DEWHURST & PARTNER LTD.
MELBOURNE WORKS HOUNSLOW

TITLE: ELEVATOR + CHAIN CONVEYOR
SCHEMATIC FOR DUST PLANT 12 & 13

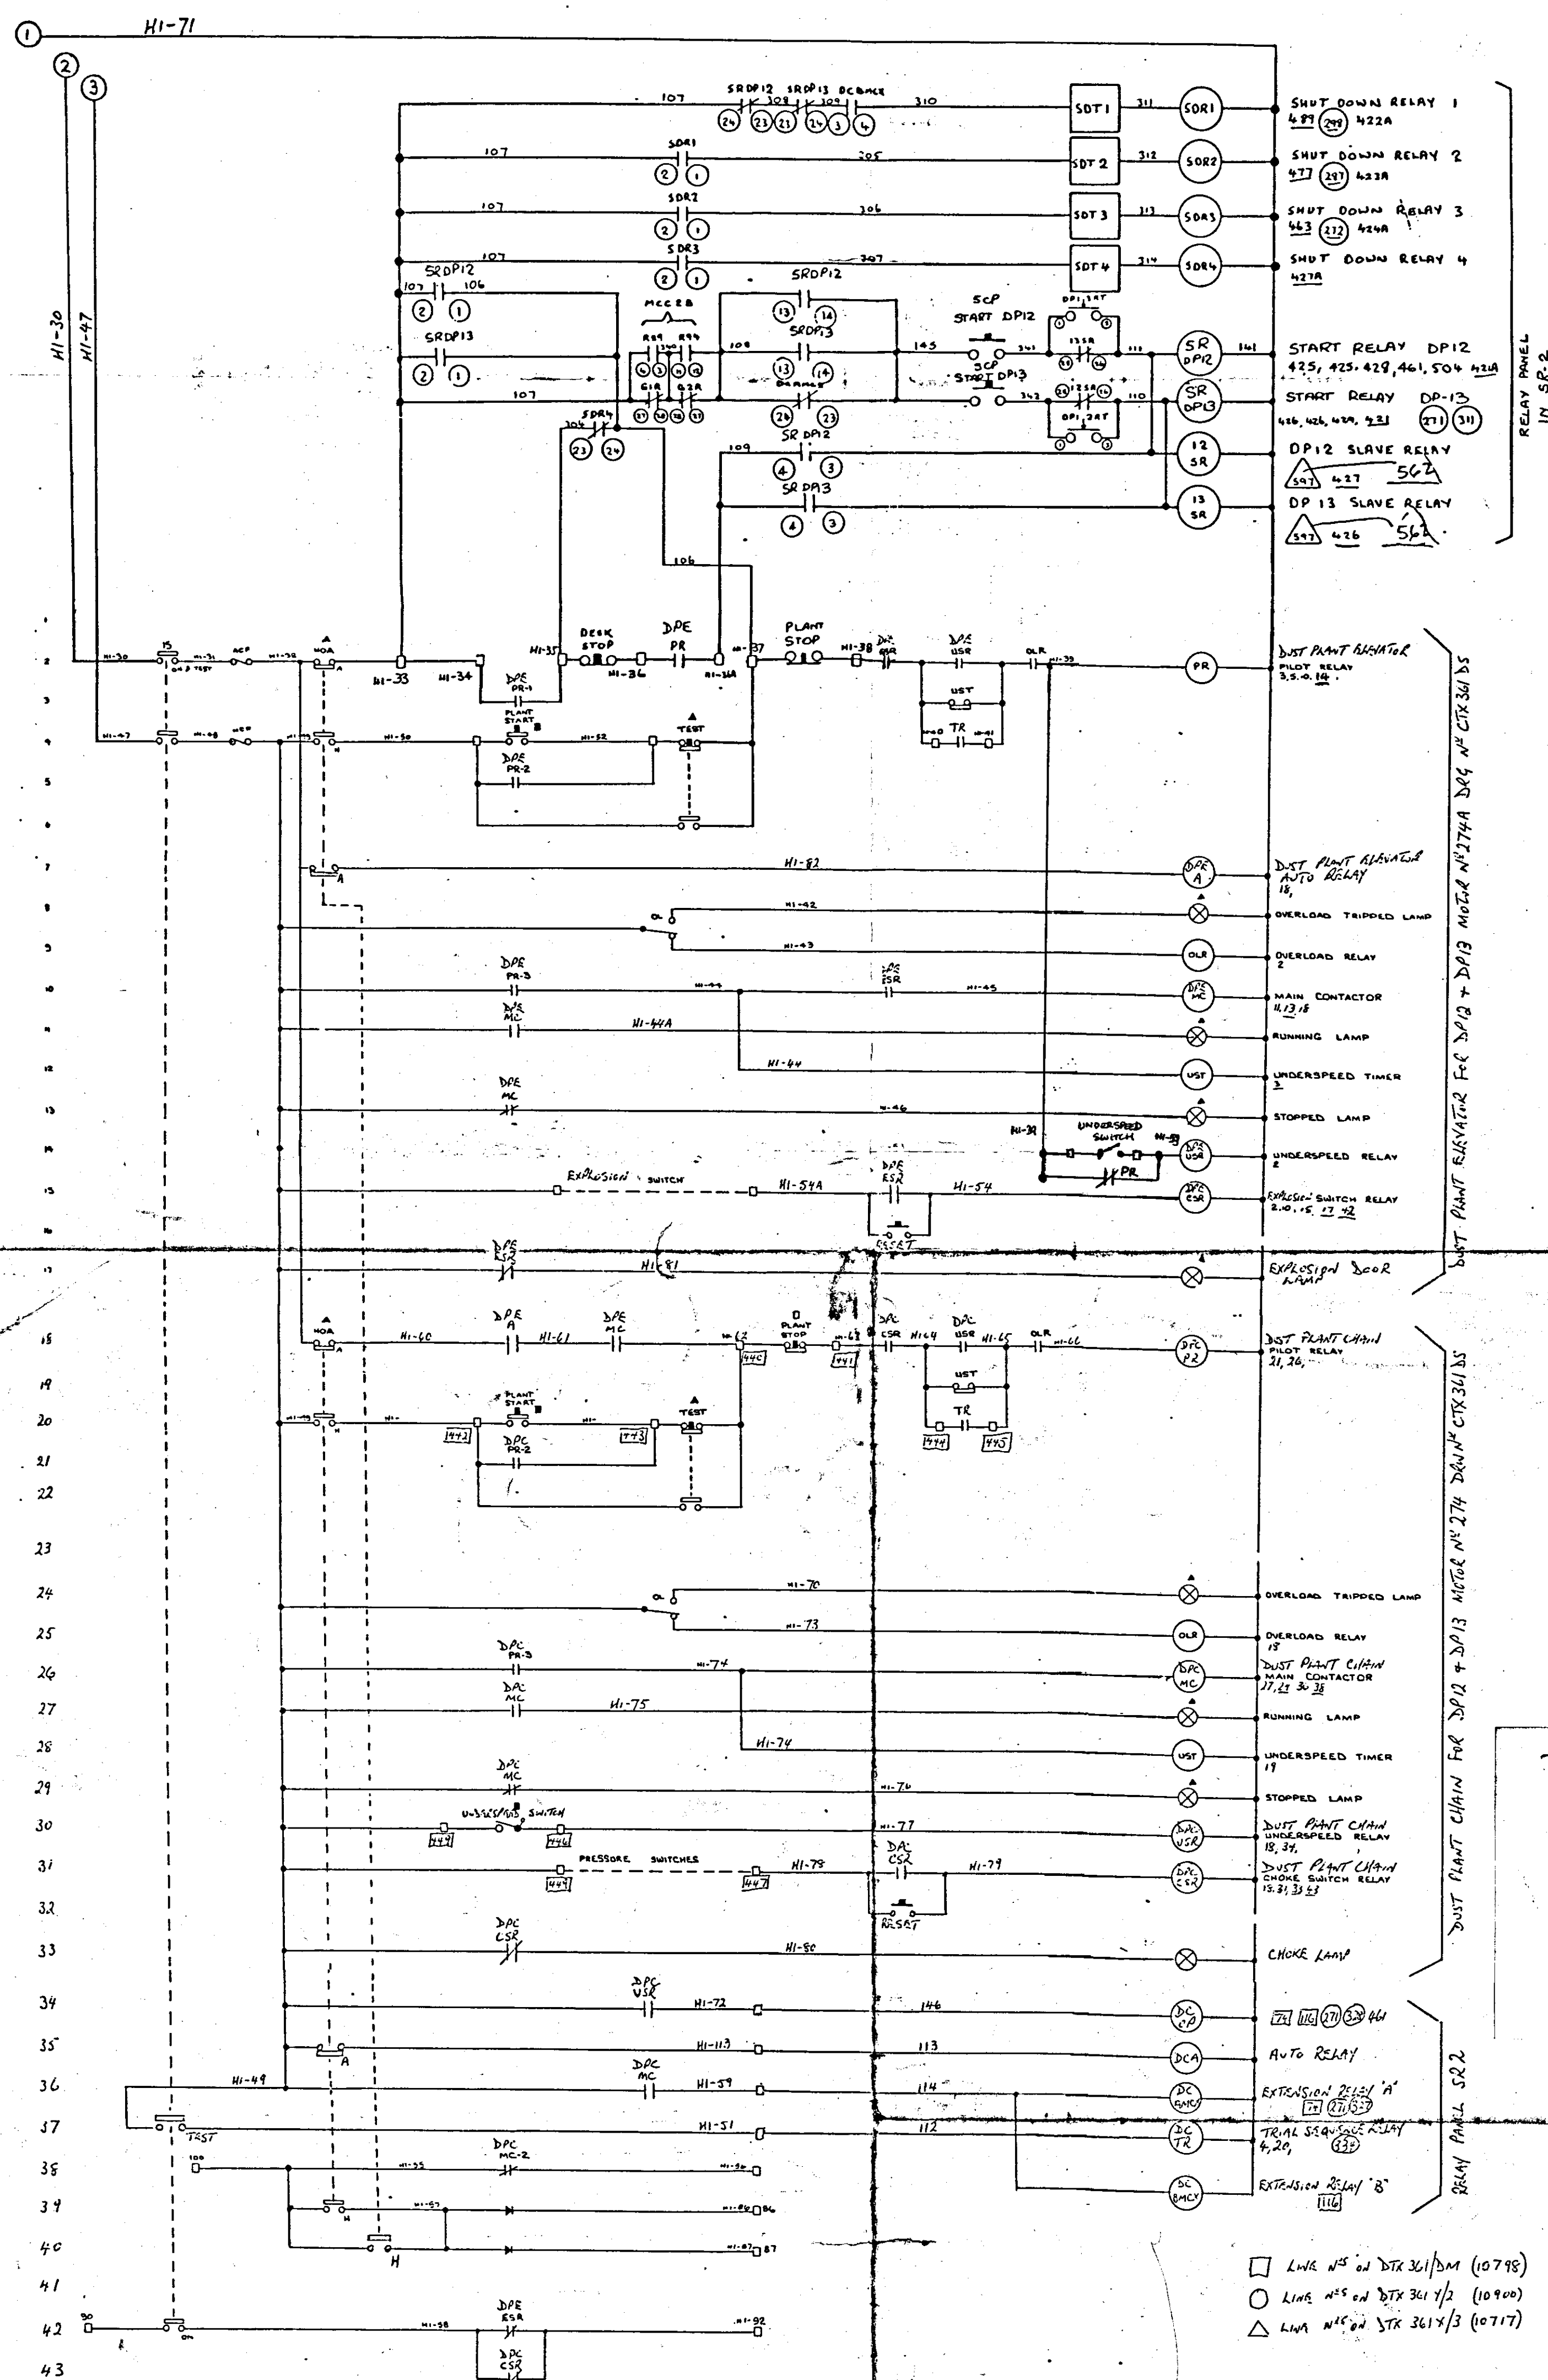
To BE REVISED
MODS TO DP12 & 13
V/Speed Switch. Control.

REVISION: 4 KW RAISING ADDED TO MOTOR NO. 210 ORIGIN: 120 2/5/77 SGD.A.I.B	REVISION: 3 MOTOR HEATER ADDED. ORIGIN: 2/4/77 SGD.J.
--	---

D/P LANT ELEVATOR FOR 12+13. CHANGED US SWITCH AND ALTERED WIRING FOR NEW INTERLOCK REVISION 6 06/05	JUST PAINT ELEVATOR FOR DP 12+13 ADD INTERLOCK FROM HI-33 TO HI-37 ADDED REVISION 5 1/94
REVISION: 2. JUST SCREW COVER REMOVED.	DRAWN BY A.M. DATE _____ CHECKED BY _____ APPROVED BY _____
ORIGIN: 73717 SGD. A.M.	DATE , _____
